NOTICE OF DECISION

**URBAN GROWTH PRELIMINARY DECLARATION / CLASS 3 SITE PLAN
REVIEW / CLASS 2 ADJUSTMENT / CLASS 1 ADJUSTMENT / CLASS 2
DRIVEWAY APPROACH PERMIT / CLASS 1 DESIGN REVIEW / PROPERTY
LINE ADJUSTMENT CASE NO.: UGA-SPR-ADJ-DAP-DR-PLA24-03**

APPLICATION NO.: 23-121805-PLN

NOTICE OF DECISION DATE: February 29, 2024

P5.0

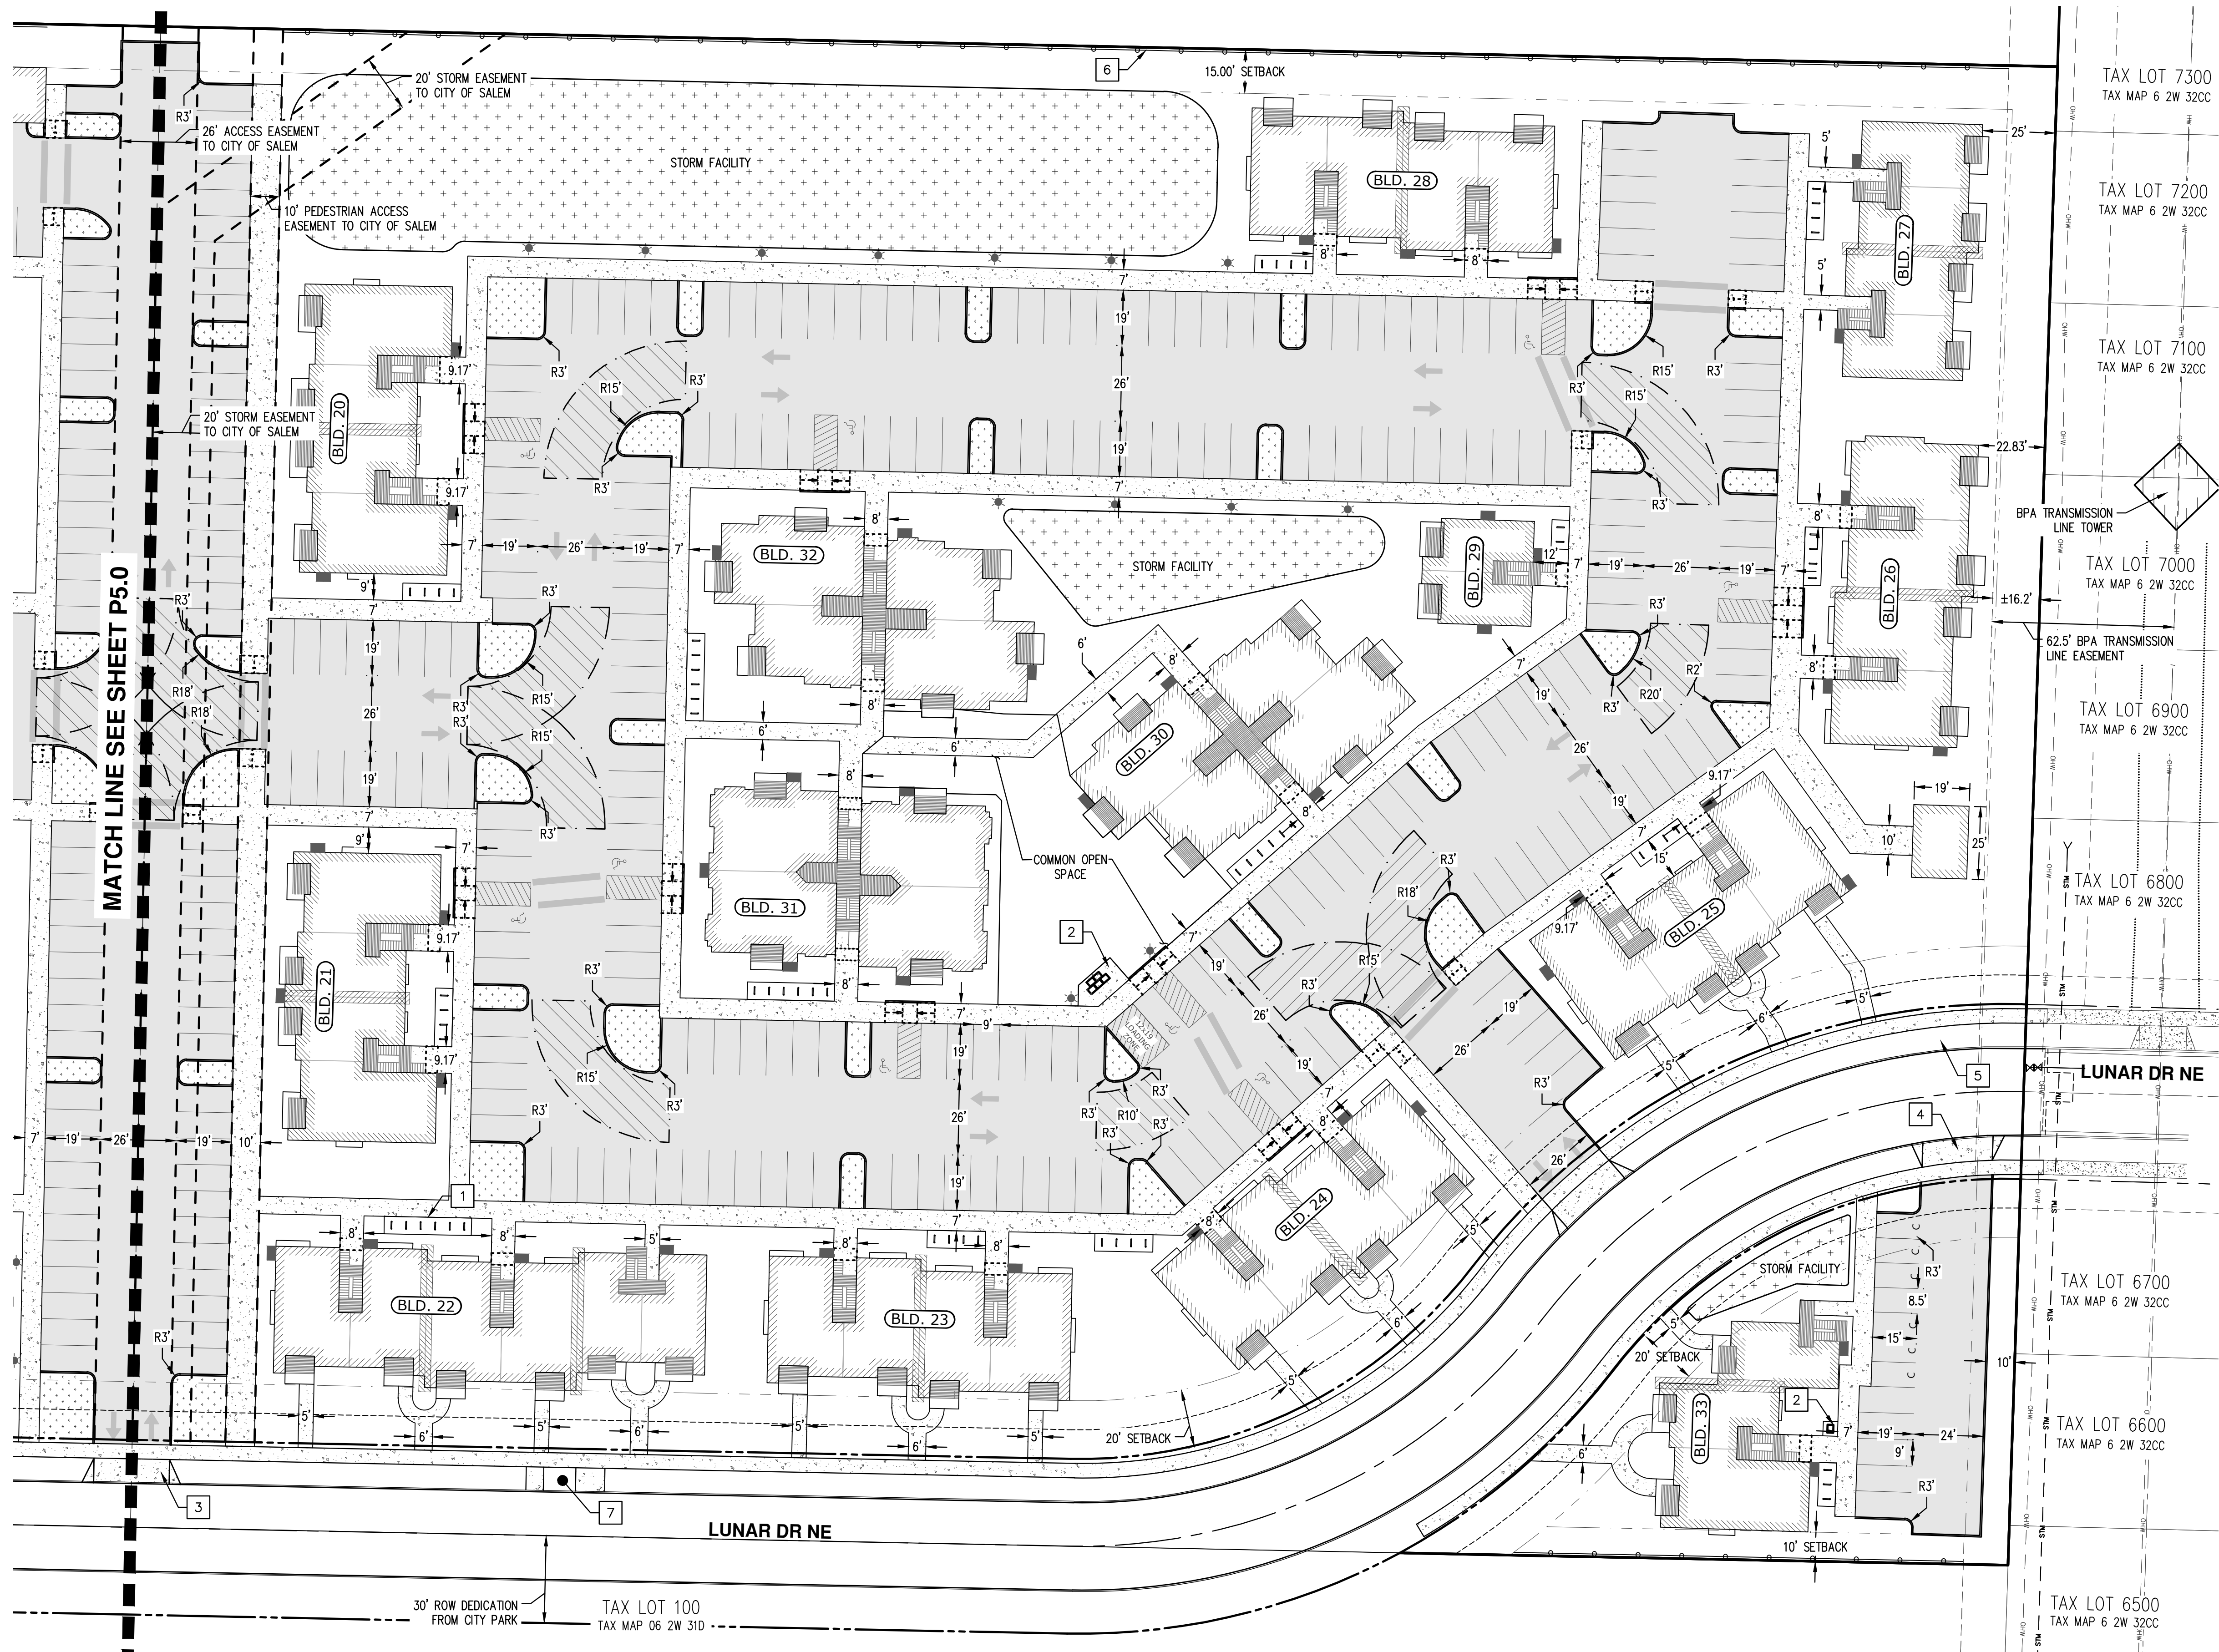
- 1) Hydrant and FDC shall not obstruct Fire Department access with hose lay. See sheet P7.0 near buildings 5 and 6.
- 2) Buildings that exceed 30 feet in height per the Oregon Fire Code require aerial access, 30-foot minimum. Appendix D105.3 as amended in SRC Chapter 58.

PRELIMINARY SITE PLAN - SOUTH
NORTHPLACE APARTMENTS PHASE 2
I&E CONSTRUCTION, INC.
SALEM, OREGON

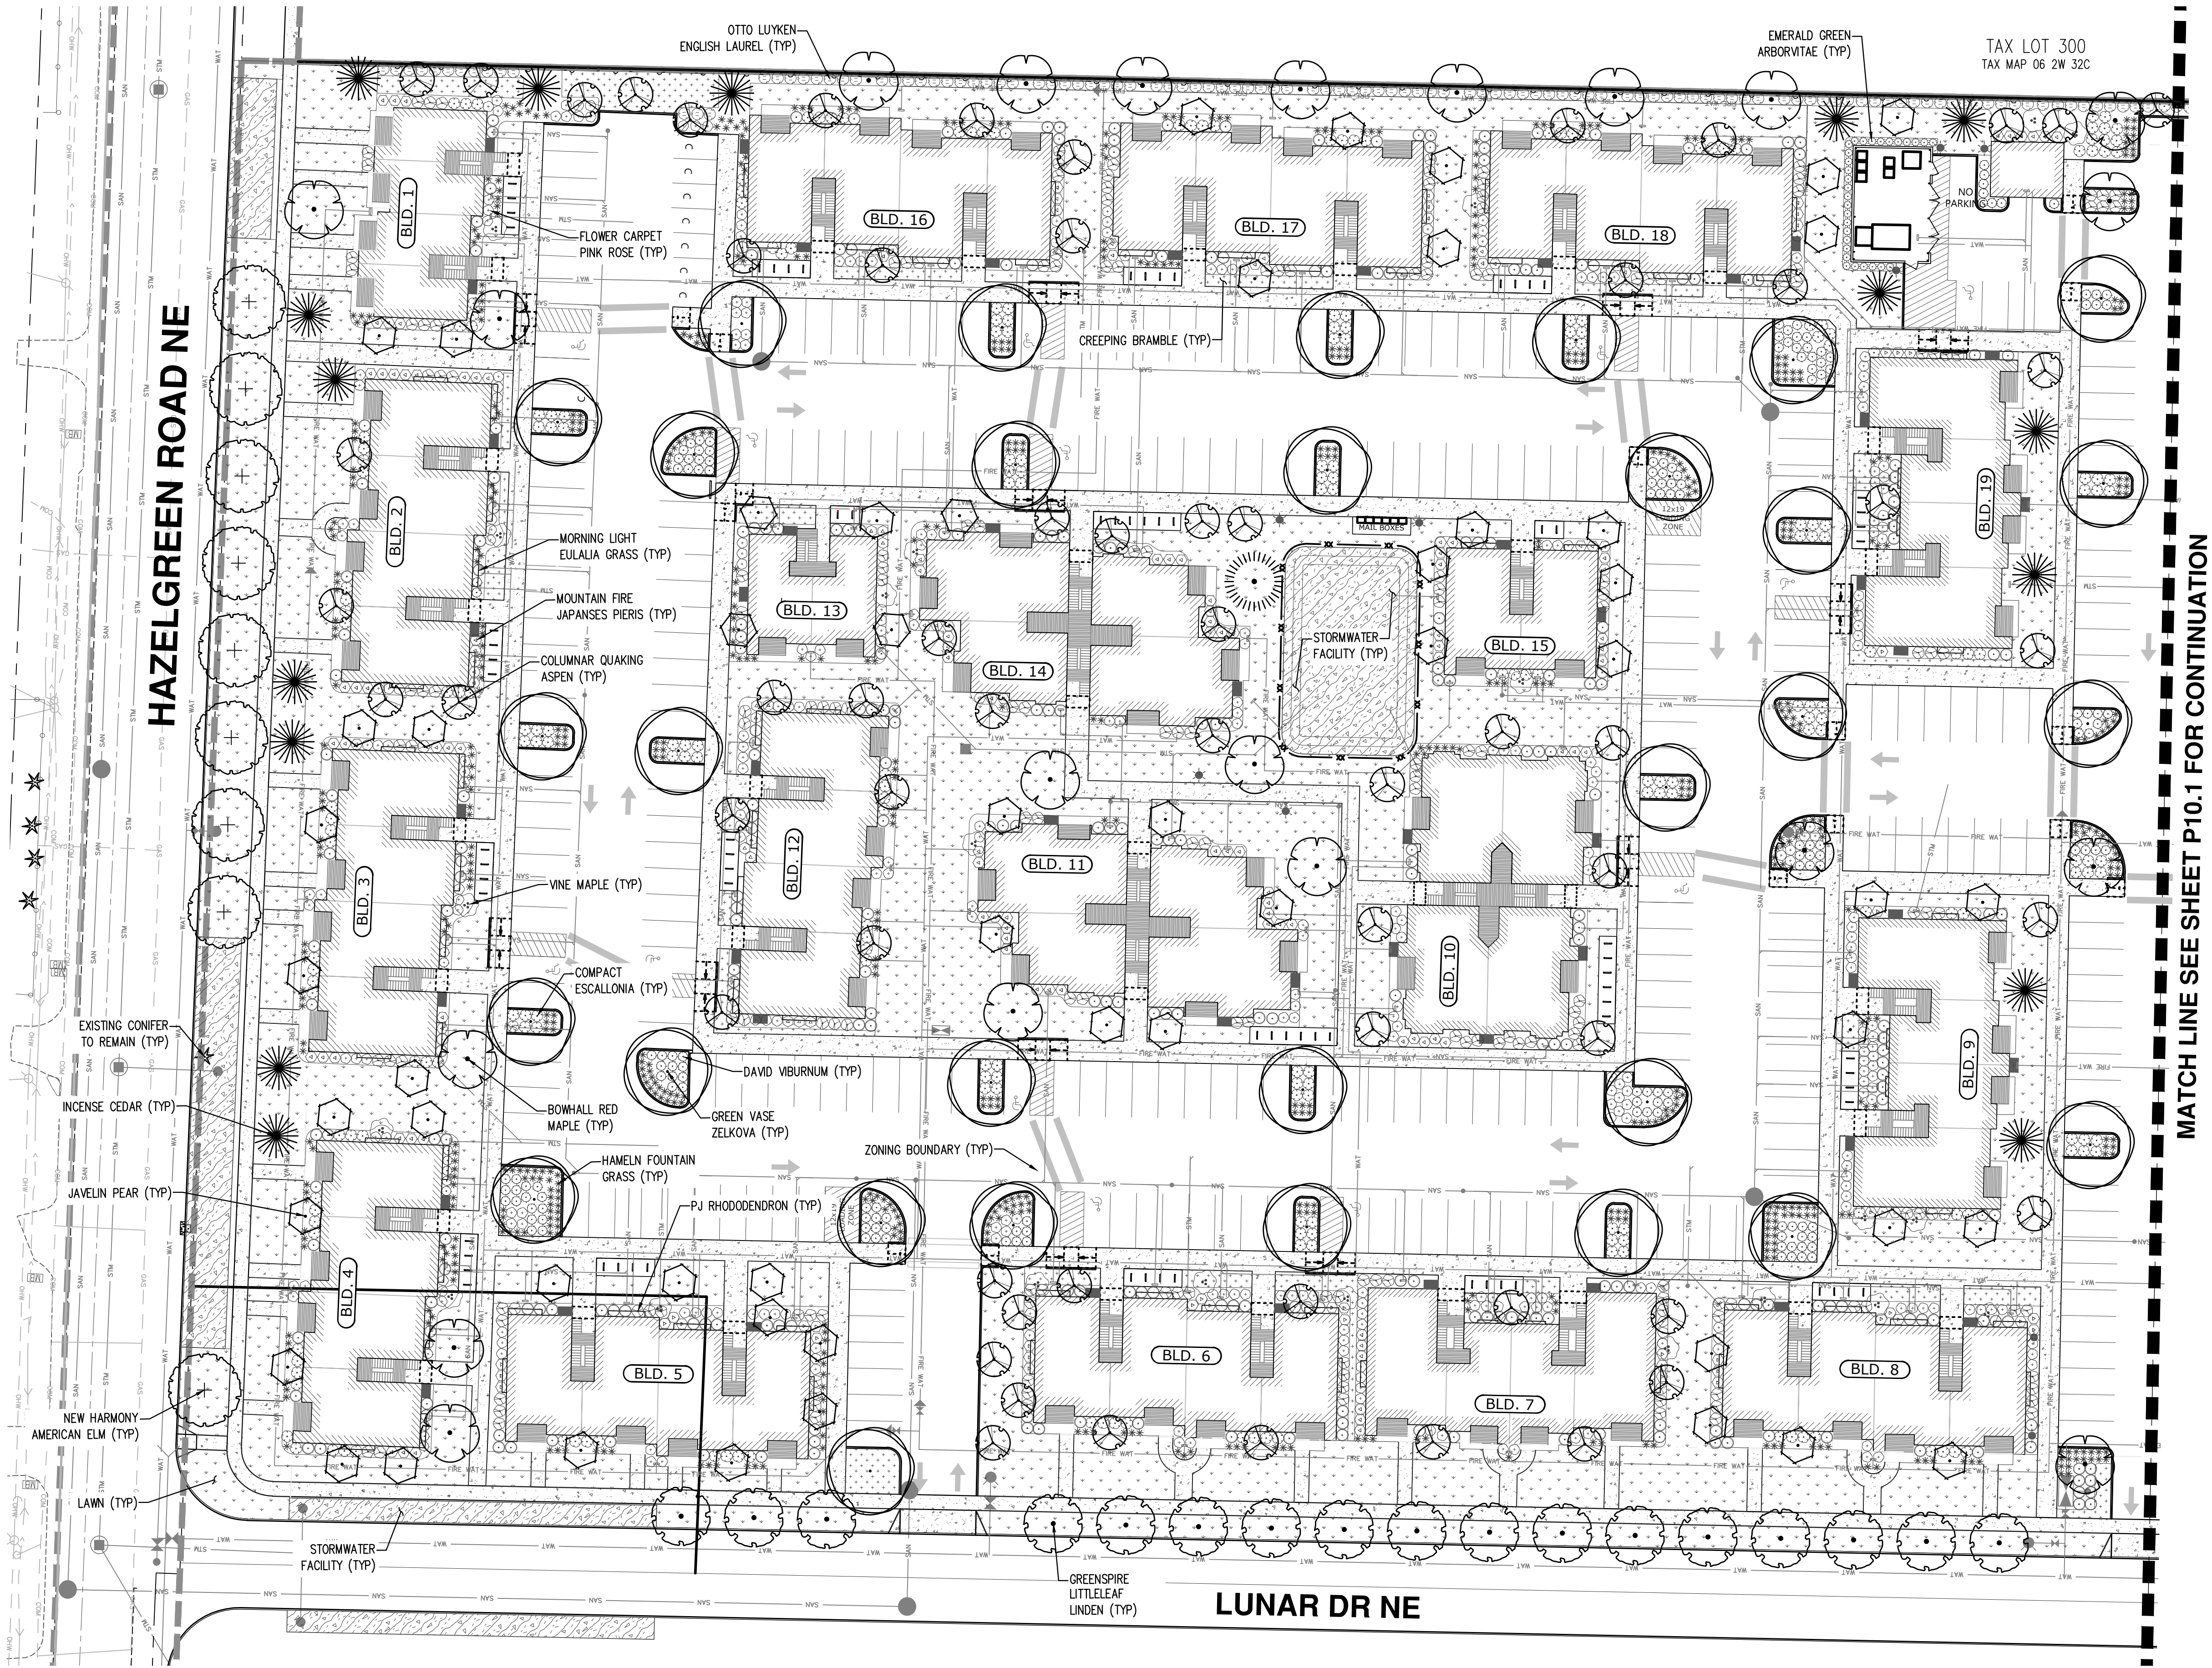
One of the transit stops shall be located on the east side of Lunar Drive at Building 5, approximately 50 feet north of the driveway as depicted in preliminary site plan drawing P5.0. The other transit stop shall be located at Building 22 as depicted in drawing P5.1 Note 7.
